Eagle Ranch Association
Regular Meeting
Design Review Board

Design Review Memorandum

Project Number: 04-07-11
Owner Name: Dick Garbarino & Martha Cabeen
Architect: Maggie Fitzgerald
Address: 148 W. Foxglove Ln
Legal: EAGLE RANCH FILING 4 Block: 7 Lot: 11
PRE-Design Meeting Date: November 13, 2024
Preliminary DRB Meeting Date: December 19, 2024
Final DRB Meeting Date:

Preliminary Review – December 19, 2024

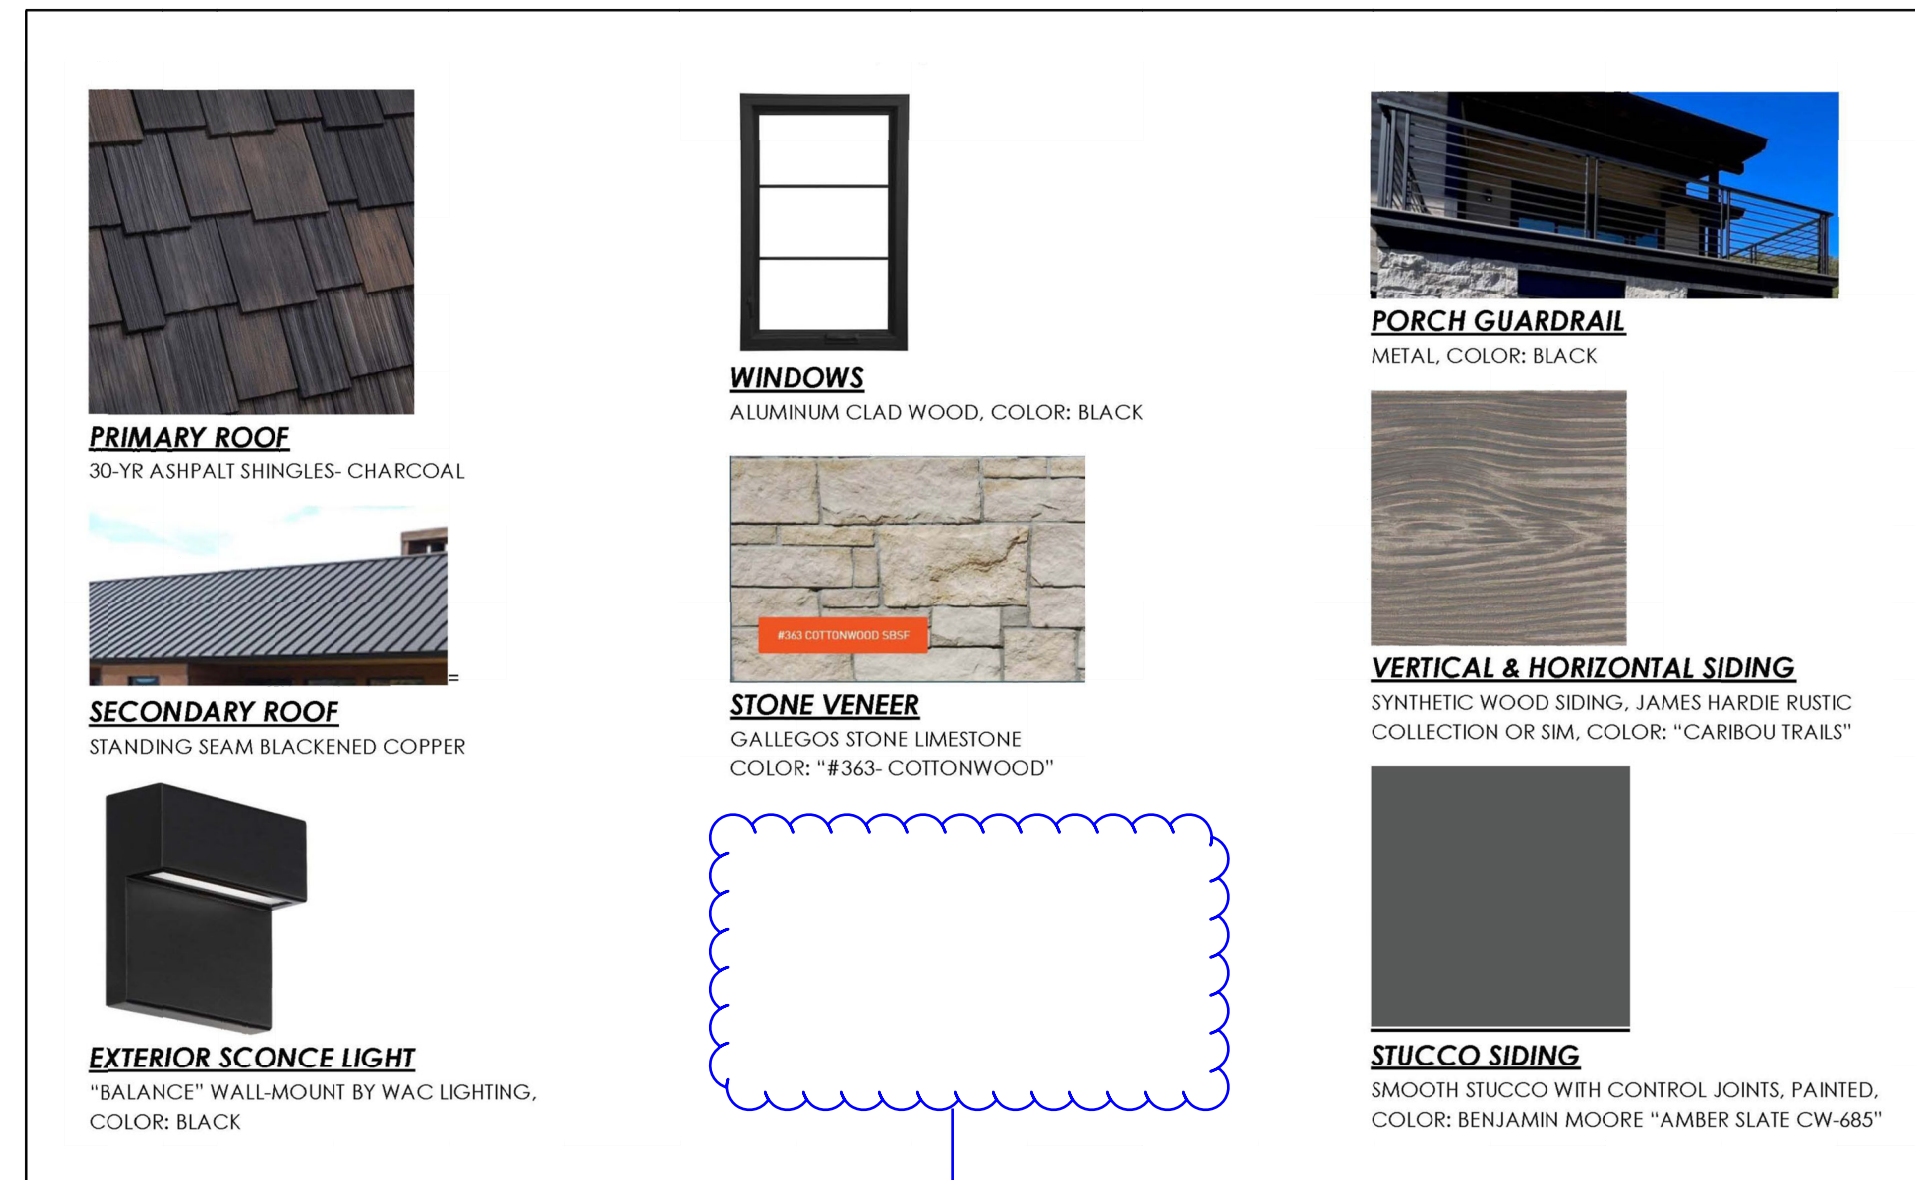
Specify trim and fascia materials/colors.

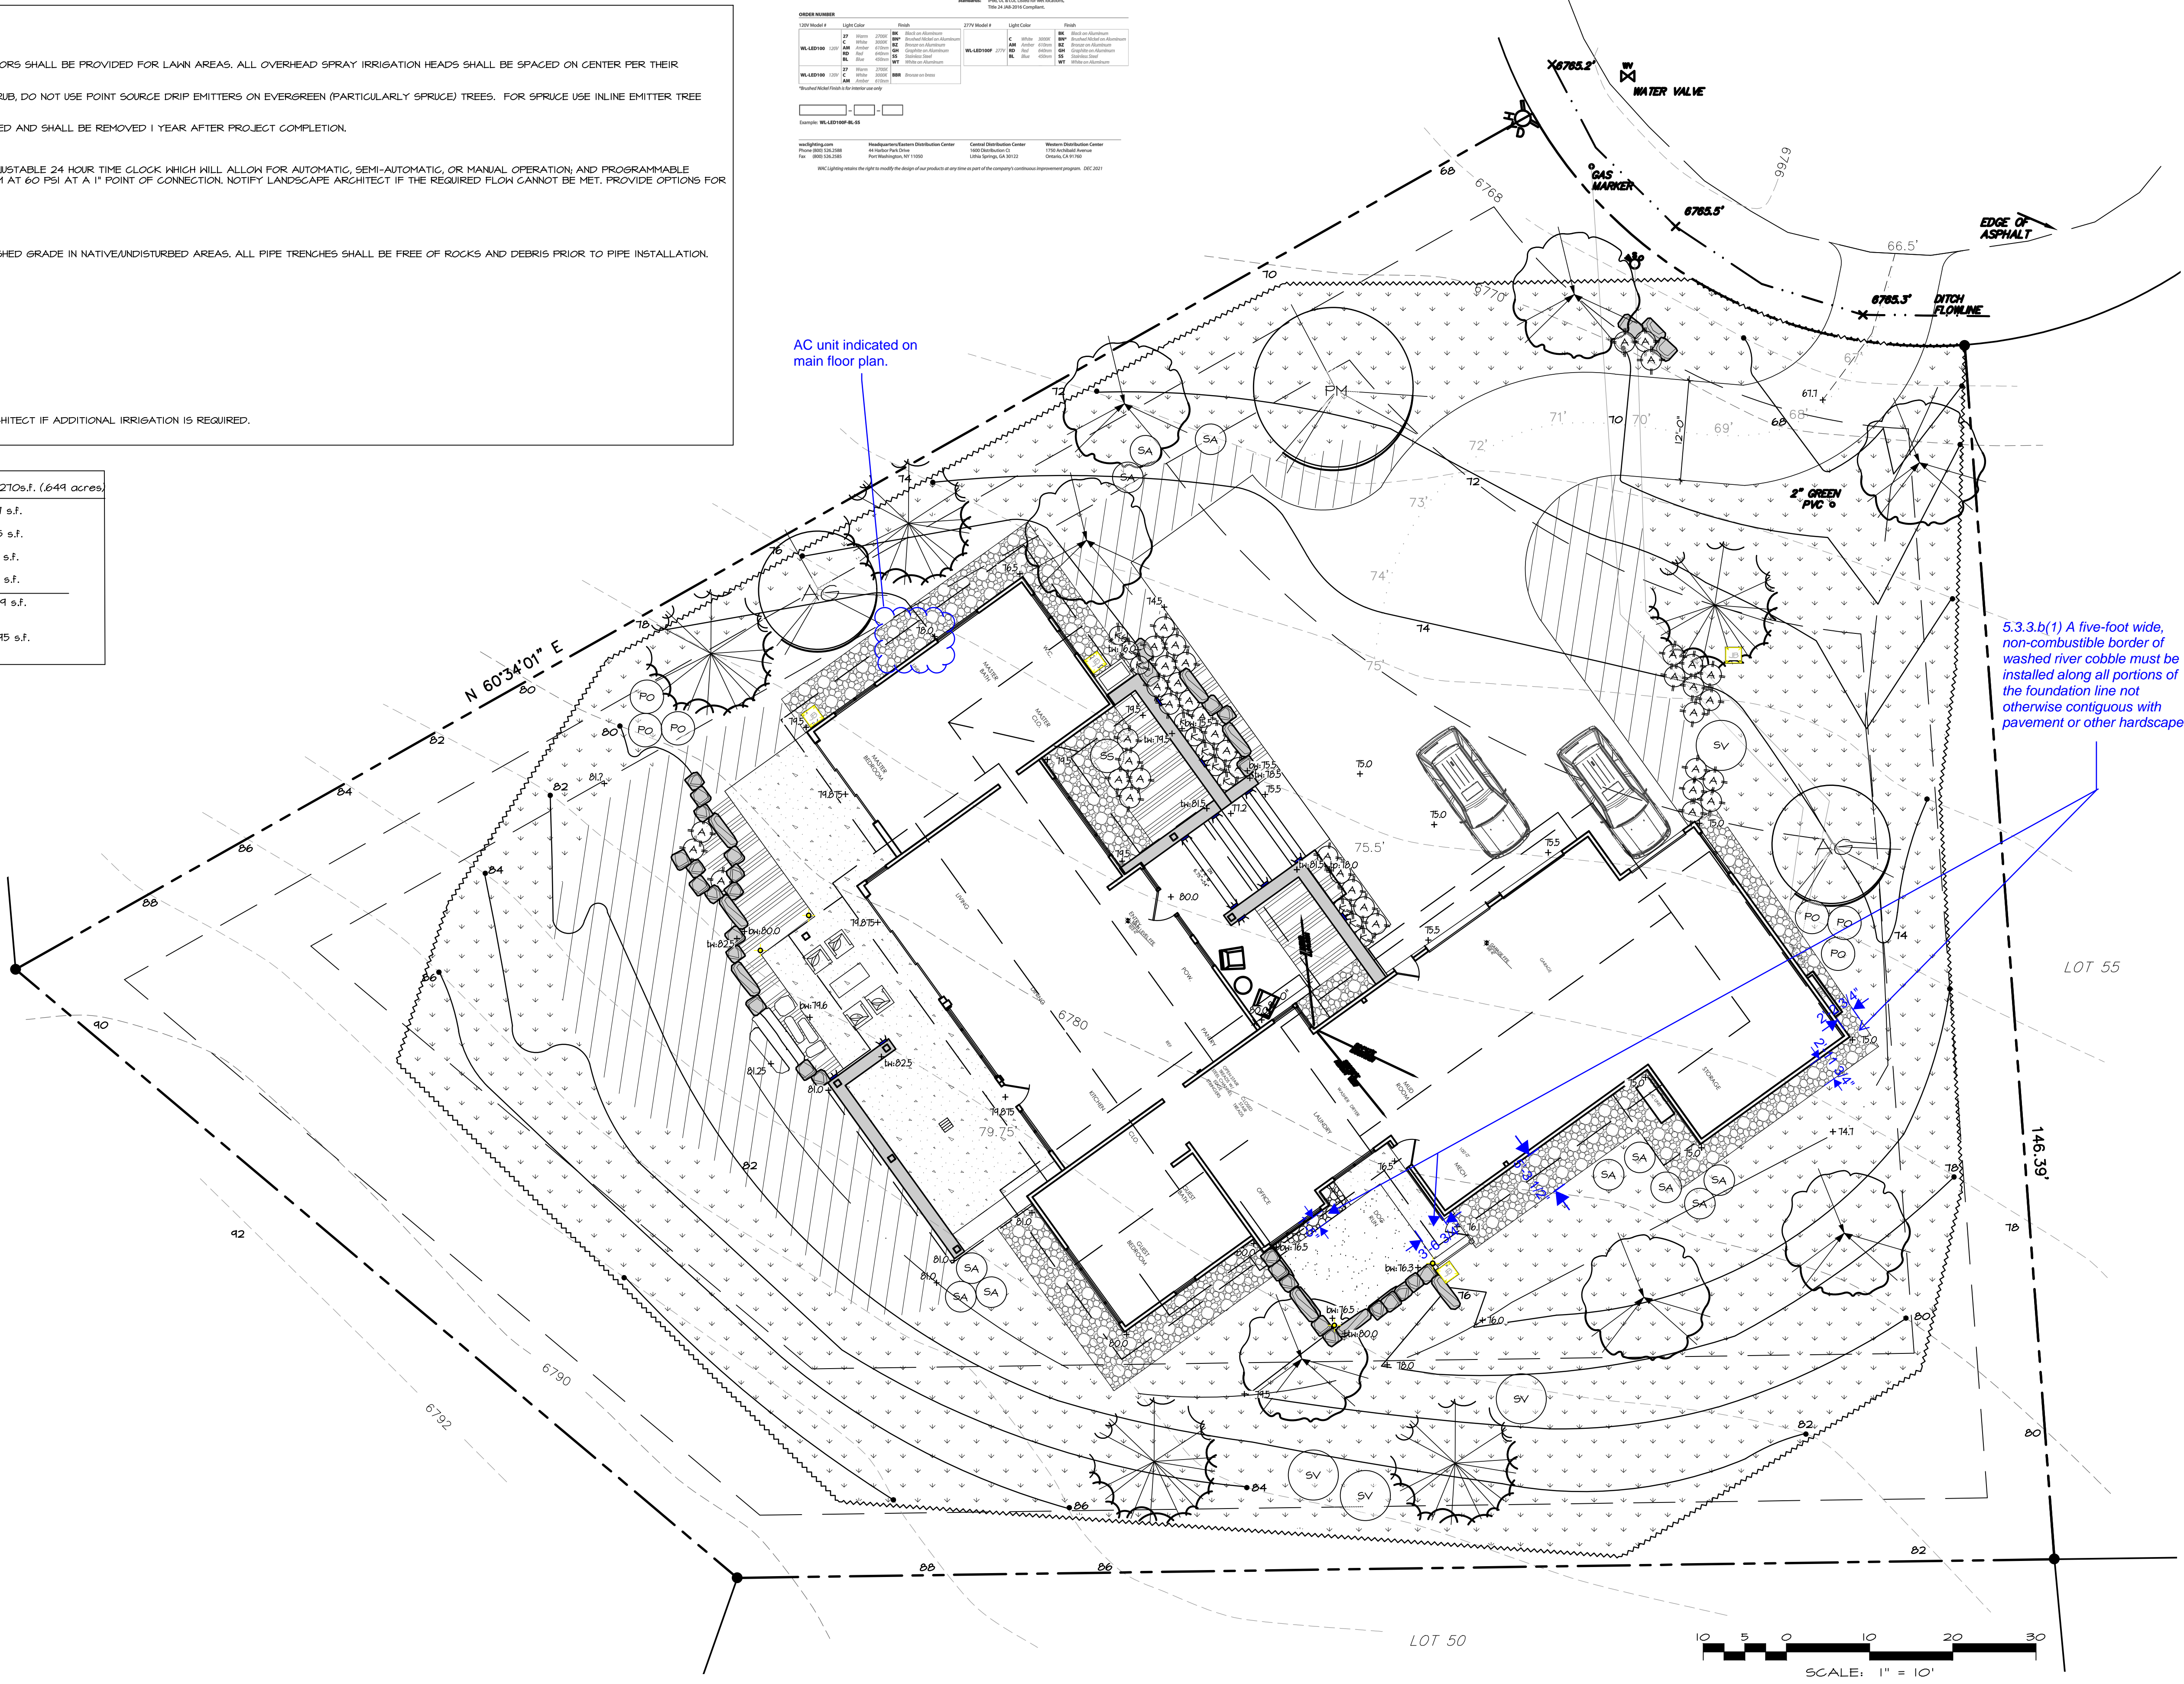
5.3.3.b(1) A five-foot wide, non-combustible border of washed river cobble must be installed along all portions of the foundation line not otherwise contiguous with pavement or other hardscape

Sheet: **L2**
© Ceres Plus, LLC. 2015

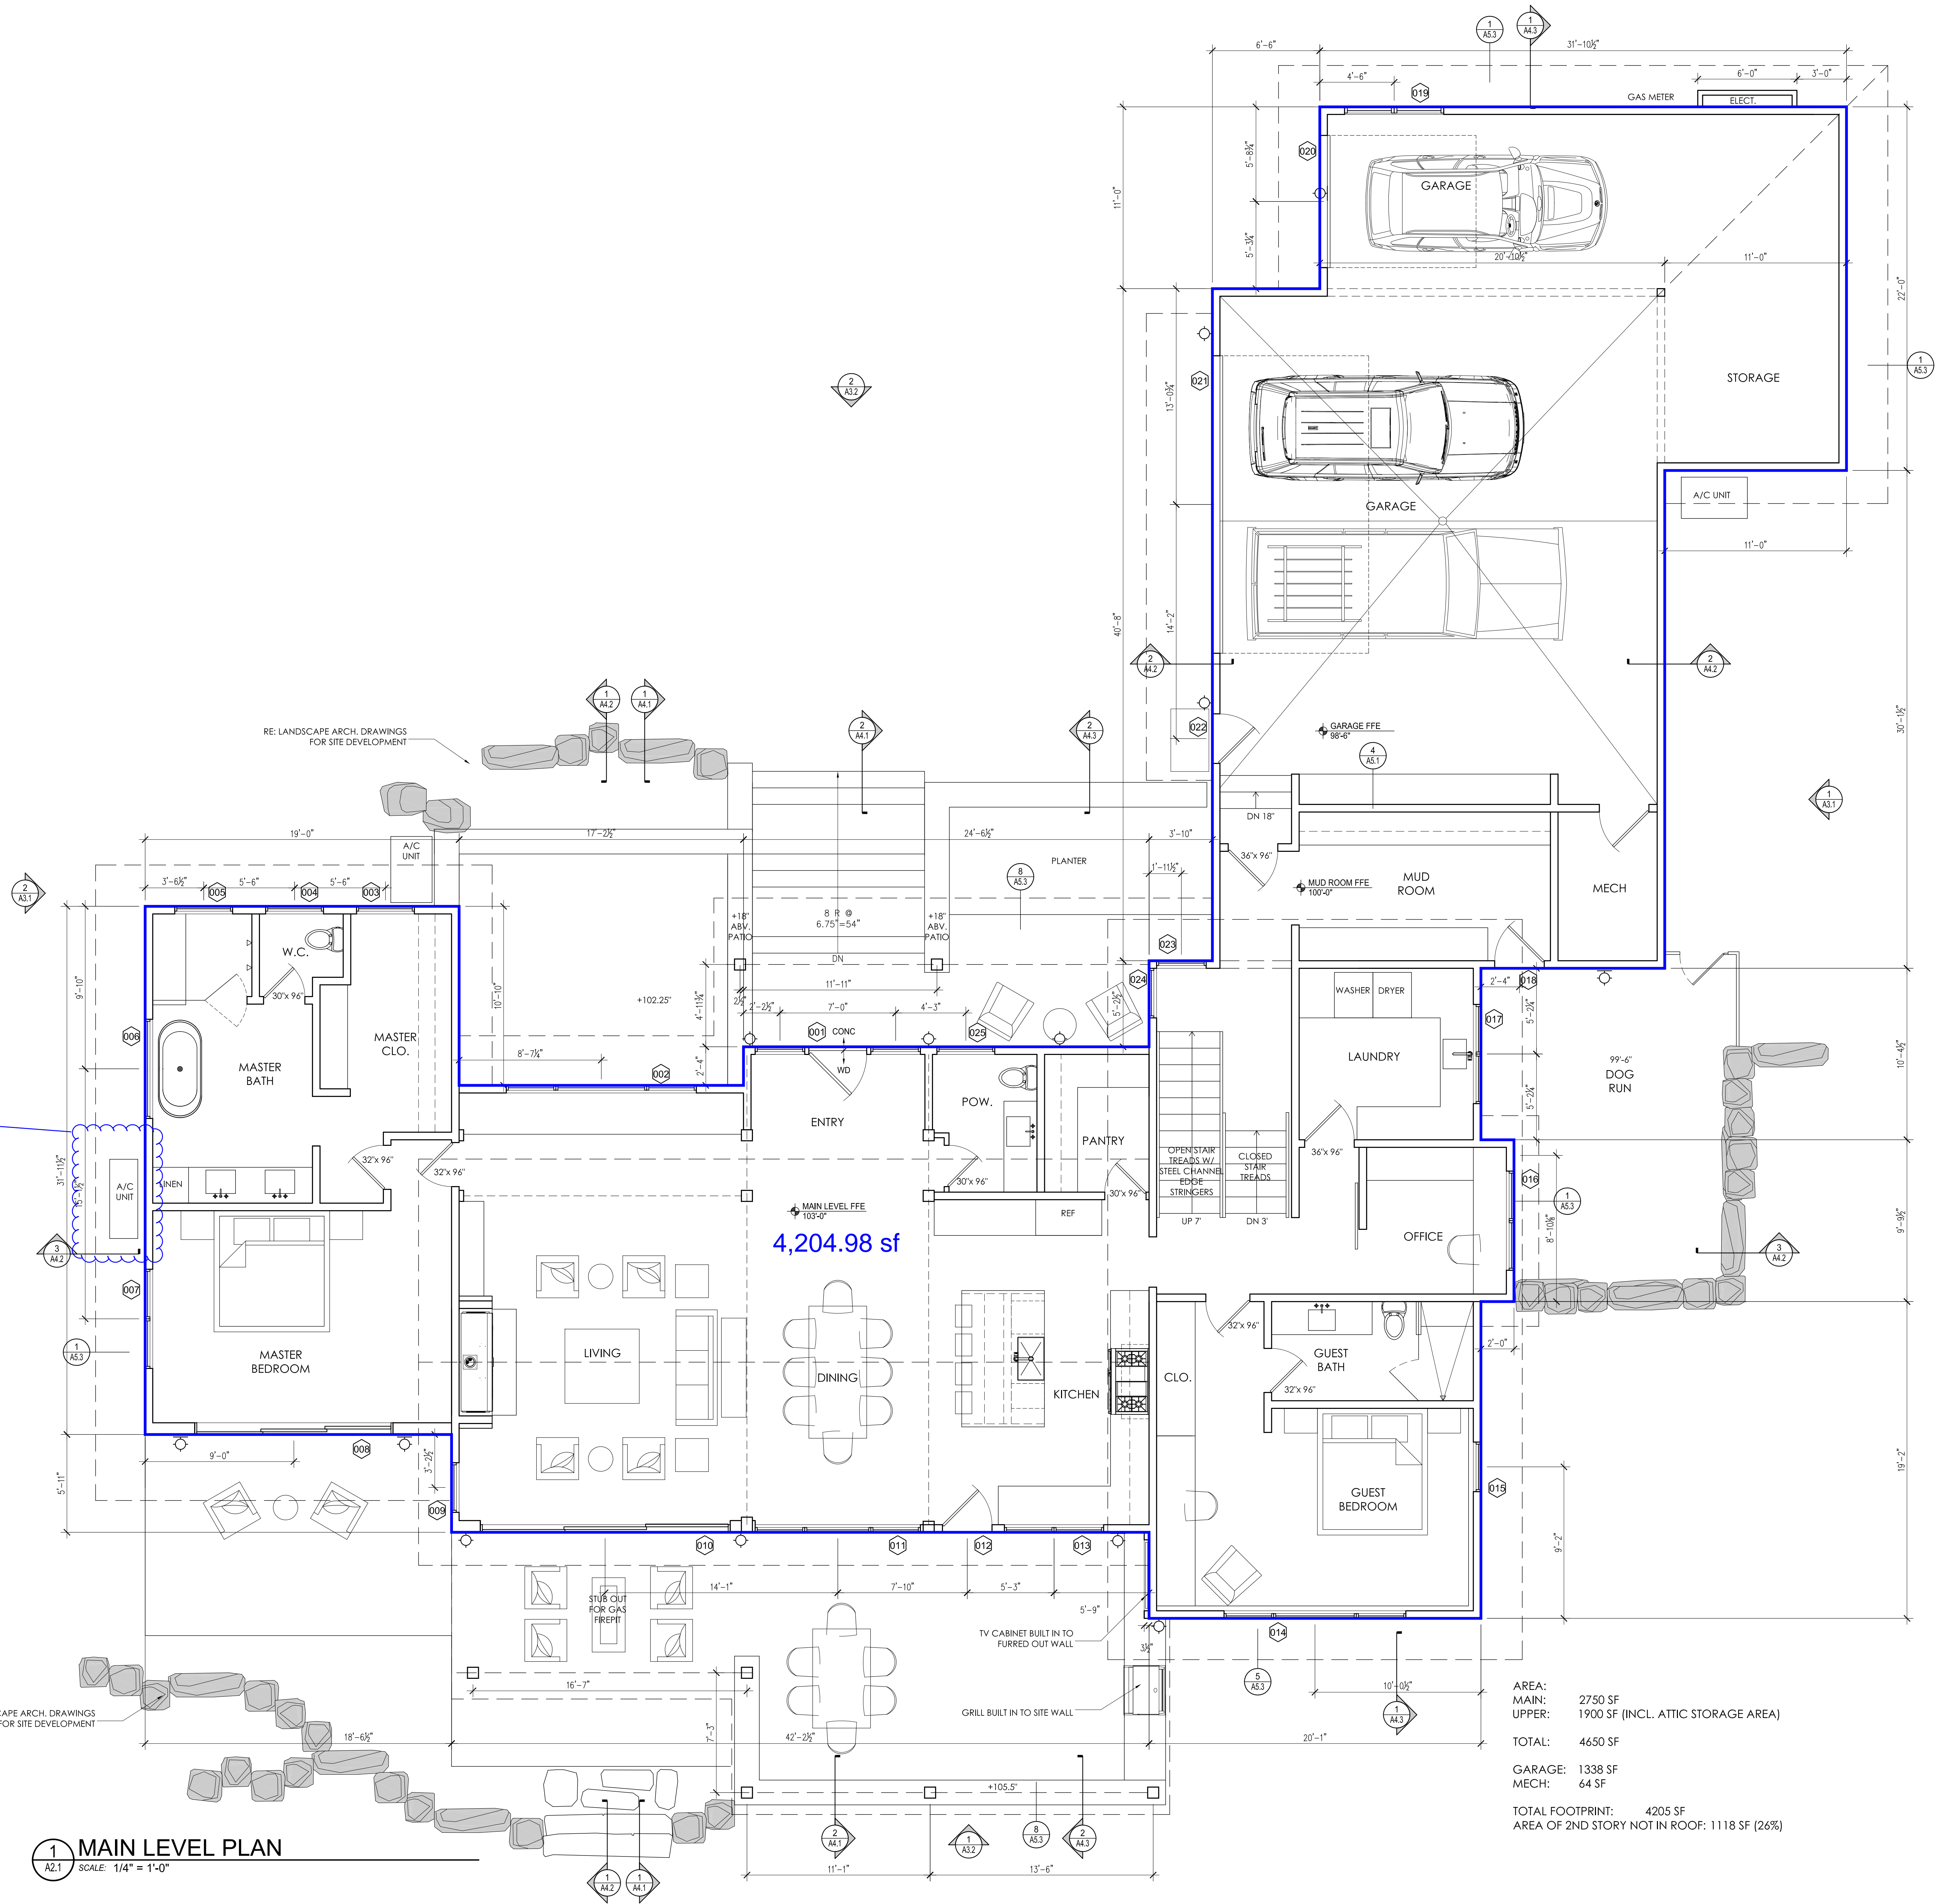
- a. *5.3.3.b(1) A five-foot wide, non-combustible border of washed river cobble must be installed along all portions of the foundation line not otherwise contiguous with pavement or other hardscape.*
- b. AC Unit shown on A2.1 Main Level Plan (NW side) not shown on site/landscape plan.

This AC unit not shown on site/landscape plan.

- d. For Final Review, include AC and mechanical locations on Landscape Plan to ensure proper screening.
- e. Forthcoming site and landscape Guidelines will require 5' non-combustible cobble border around structure. While not currently required, applicant could consider for Wildfire Defensible Zone 1. Perimeter material not specified on Legend.
